Groundwater Transfer Review Summary Form

Transfer/PA # T- 13869

Application: T-13869

Applicant Name: Highland Subdivision Water District

Groundwater Level Data

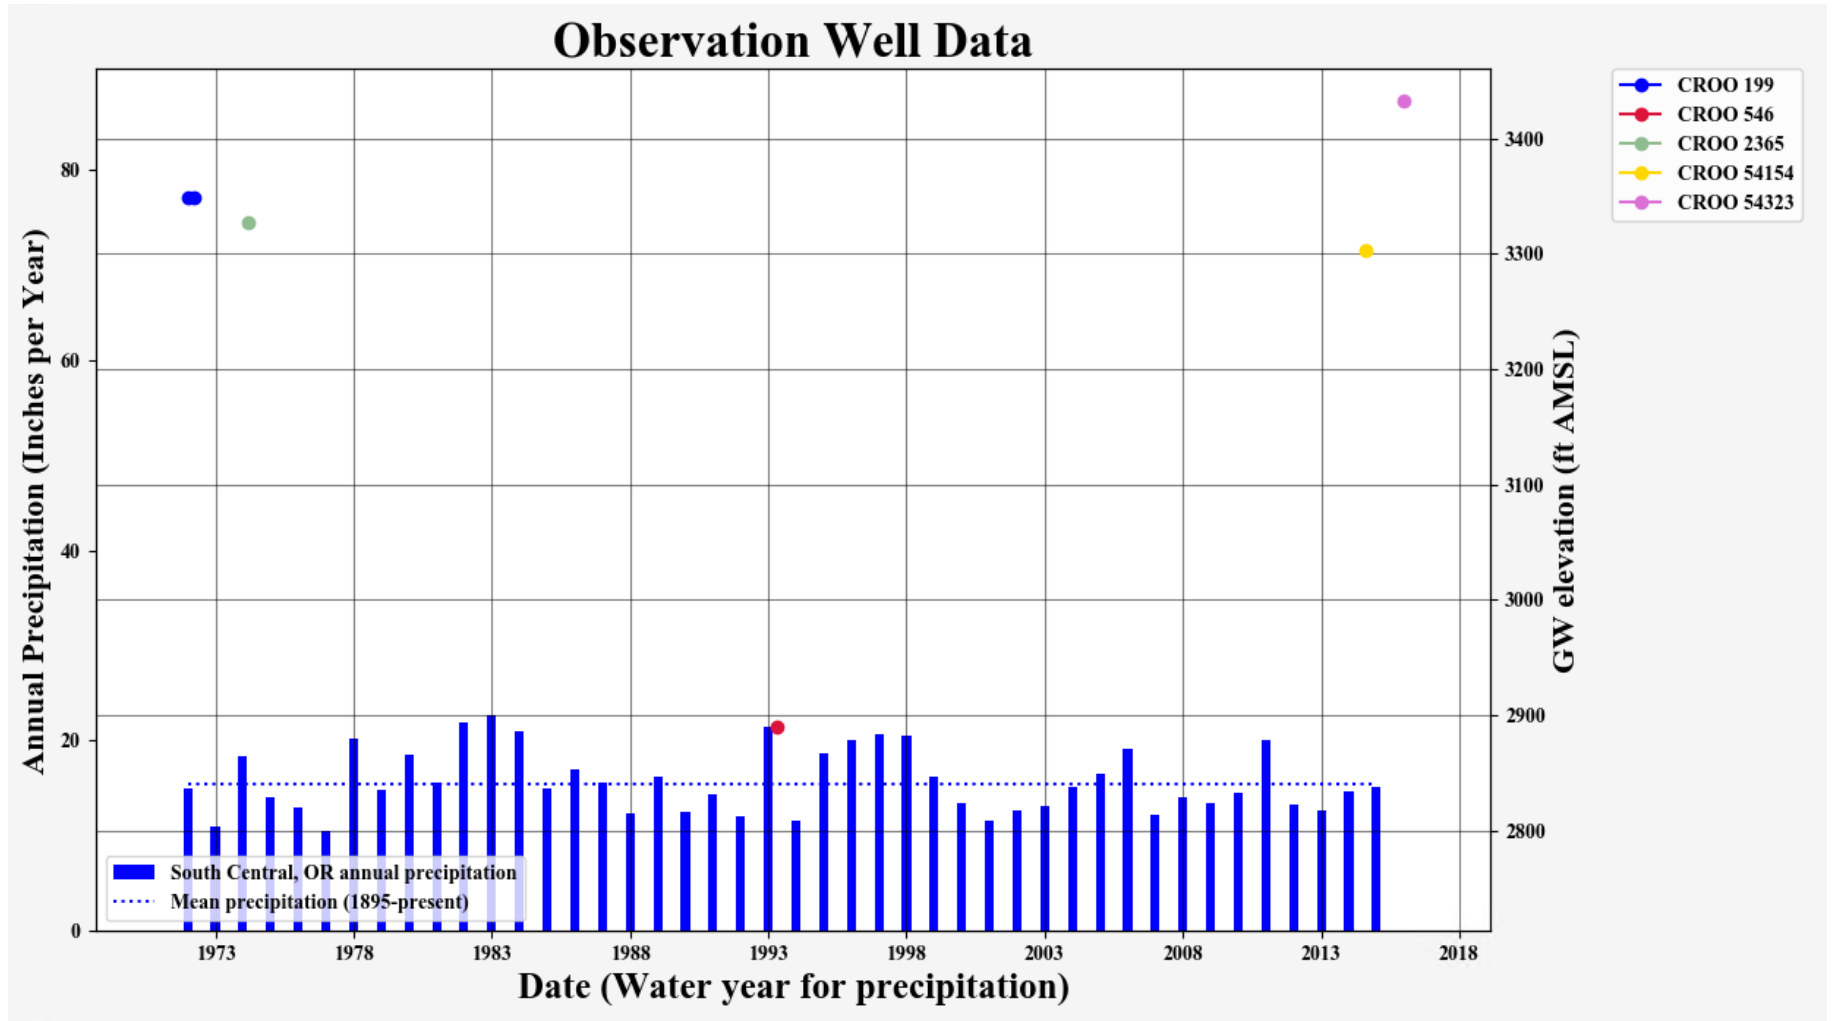
2. Will the proposed POA develop the same aquifer (source) as the existing authorized POA?
 - Yes No Comments: CROO 546 (current valid POA) is drilled to 450 feet and produces groundwater from unconsolidated sediment, likely Quaternary-aged alluvium deposited by the Crooked River. CROO 546 is located 350-feet from the Crooked River; the only reported water level in the well is coincident with the elevation of the river. Both APOAs are located ~1.5 miles east of CROO 546 in the Juniper Canyon area. CROO 199 is drilled to 250 feet and produces groundwater from tuffaceous sedimentary rocks at depth (Tmos of McClaughry and Ferns, 2007). CROO 2365 is drilled to 290 feet and also accesses groundwater hosted within Tmos. Groundwater levels in both APOAs are several hundred feet higher than the valid POA (see hydrograph below). Considering the different geologic material and water level elevations, the proposed APOAs would produce from a different source than the current POA.
